UPPER UWCHLAN TOWNSHIP  
PLANNING COMMISSION  
AGENDA  
**June 13, 2024**

TO: Upper Uwchlan Township  
FROM: Richard Ruth, Upper Uwchlan Township Fire Marshal  
DATE: May 13, 2024  
RE: 301 Park Road – P.J. Reilly Headquarters – Land Development Plan

I have reviewed the plans for 301 Park Road – P.J. Reilly Headquarters land development plan dated November 1, 2022, and last revised March 28, 2024 and offer the following comments:

1 SOUTH ELEVATION

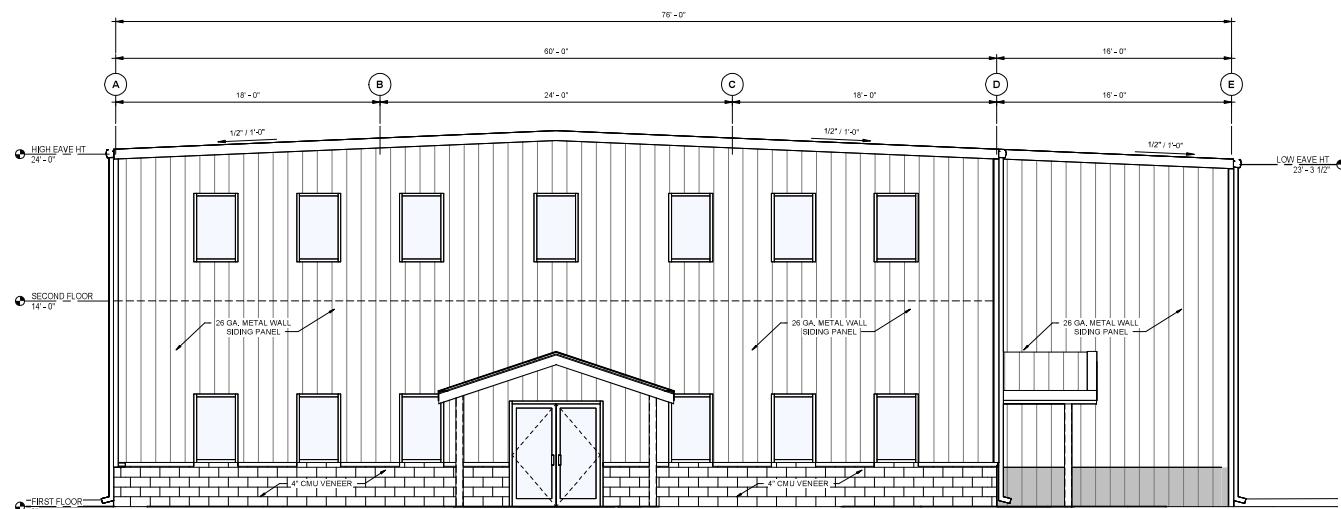
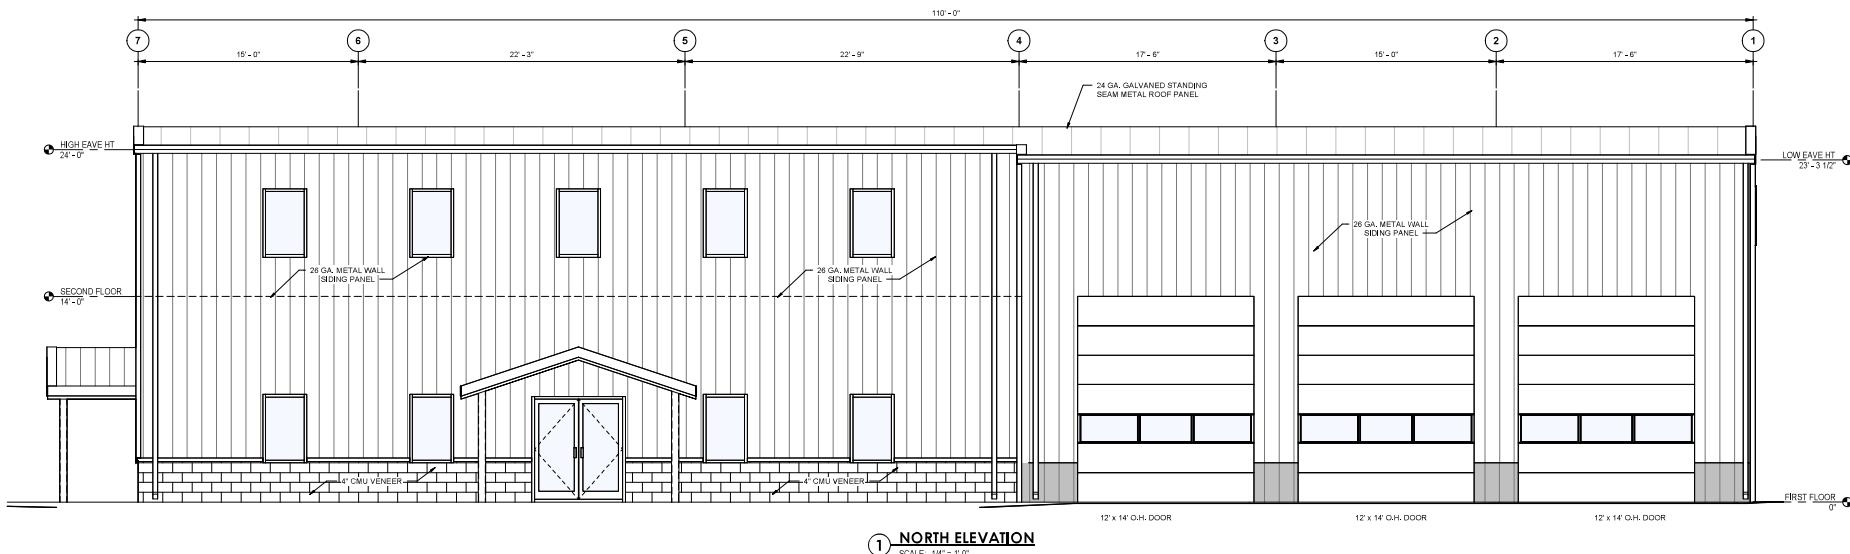
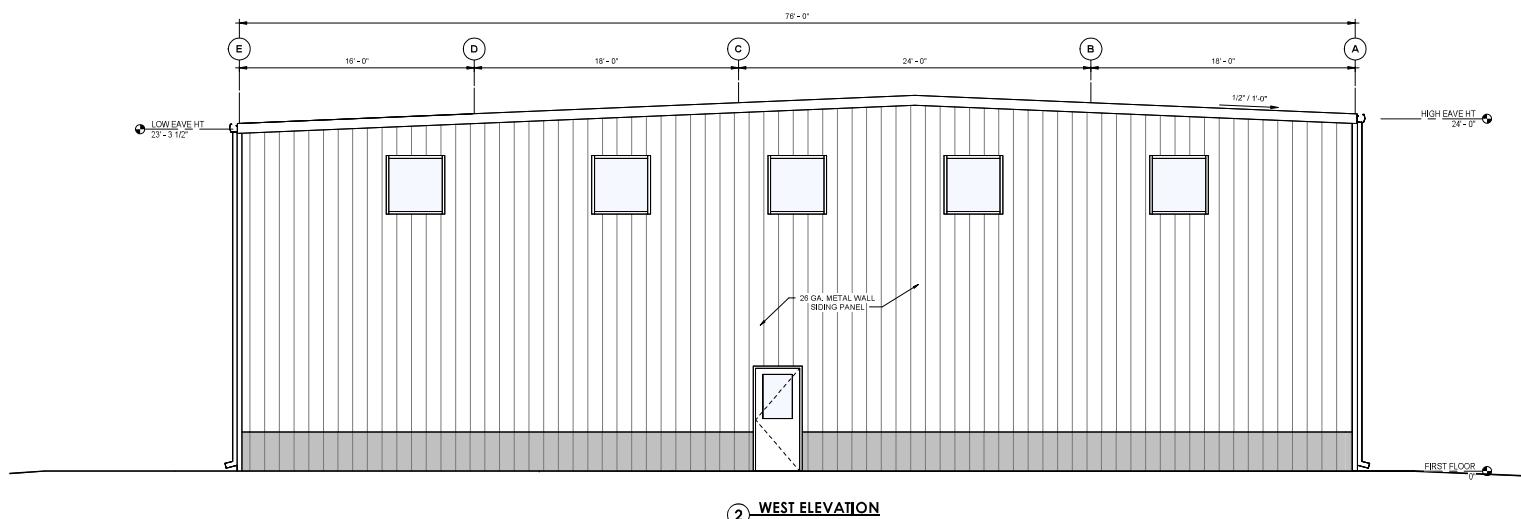
3. It appears that all proposed building mounted light fixtures may be in conflict with window locations at the 20' mounting height shown. Fixture locations shall be coordinated with architectural elevations to ensure mounting is feasible as proposed.
4. Note on plan “Architectural design to ensure 5 FC illumination at all entrances” seems to indicate that there will be additional architectural light fixtures proposed. Additional information shall be provided for these proposed fixtures.
